STAFF REPORT: 11/13/2024 MEETING

ADDRESS: 1624 EDISON

APPLICATION NO: HDC2024-00434

SCOPE: REHBAILITATE DWELLING AND GARAGE

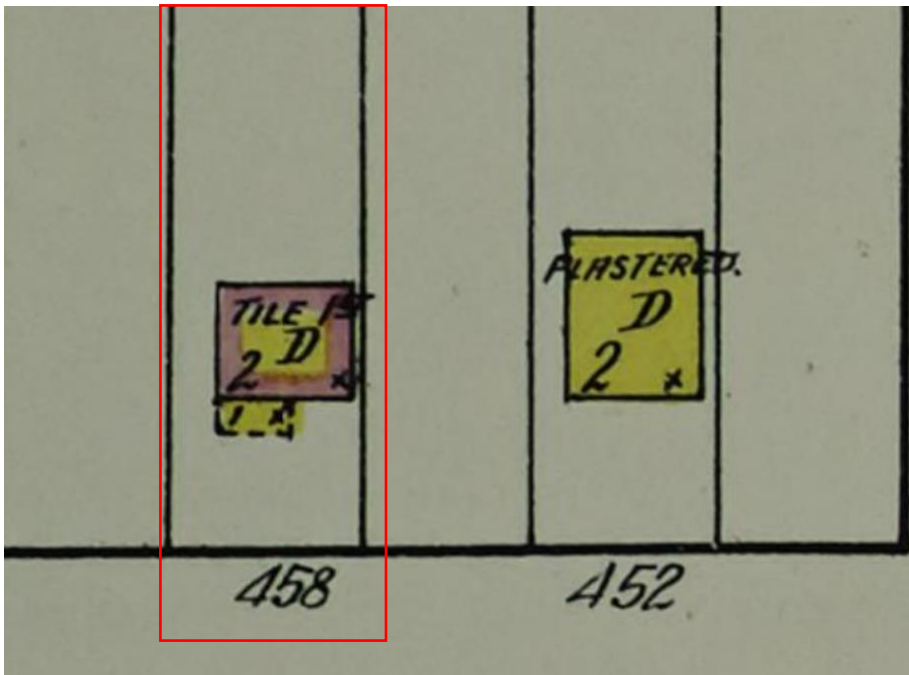
- The Boston-Edison Historic District was designated in 1973
- Please see the appearance of the house at the time of the district’s designation to note that exterior walls were clad with non-historic aluminum siding and PermaStone/synthetic stone.

The chimney, porch deck and columns were also clad with non-historic Permastone. However, note that the original 6/1 wood windows remained, and the roof's original wood fascia/soffits were present despite the presence of the non-historic siding.
